Subject: CHECK ENGINE LIGHT ON WITH DTC P0300-P0304	Bulletin No: 01-014/16
	Last Issued: 06/10/2016

APPLICABLE MODEL(S)/VINS

YUMEBISHI-produced (NO GOOD)	MITSUBISHI-produced (GOOD)
 <p>3208a</p>	 <p>3208b</p>

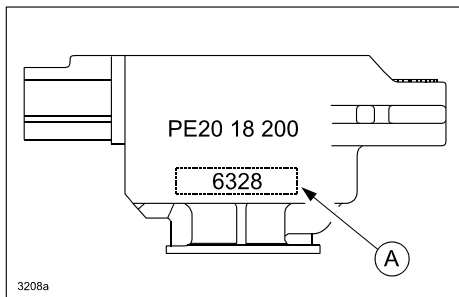
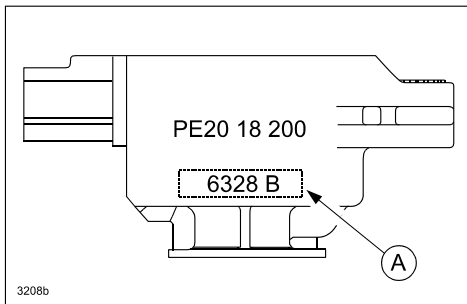
NOTE: The ignition coils are supplied from two different vendors, YUMEBISHI and MITSUBISHI. This concern only occurs on YUMEBISHI- produced ignition coil.

To distinguish between YUMEBISHI and MITSUBISHI ignition coils, look at their lot numbers (A). YUMEBISHI have 4 digit lot numbers and MITSUBISHI have 5 digit lot numbers as shown.

NOTE: There is no part number change. Differentiate the new modified ignition coil (YUMEBISHI-produced) from the old one by the lot number on the ignition coil. Ignition coils with the lot number of 6328 (March 28, 2016 production) or higher are modified.
